KK1L 2x6 Switch

Addendum

[Errata]

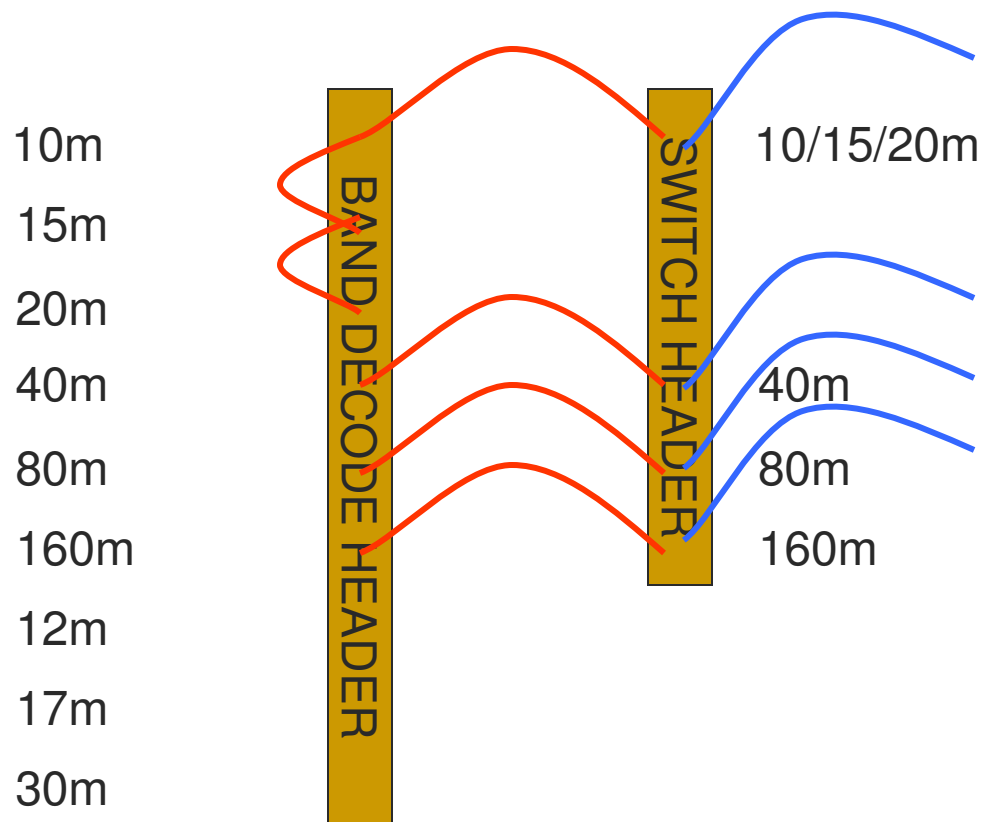
- Holes for SIPs too small
- Holes for rectifier diodes too small
- Holes for 7812 too small
- Need 0.01uF caps on relay lines for RF suppression
- Transistor pins easy to bridge
- Board comments confusing

- Fixed all holes size problems
- Change all noise suppression caps to 0.01uF
- Added RF suppression caps to relay lines
- Fixed transistor pins easy to bridge
- Enhanced board comments
- Added SIP locations to make antenna selection wiring easier
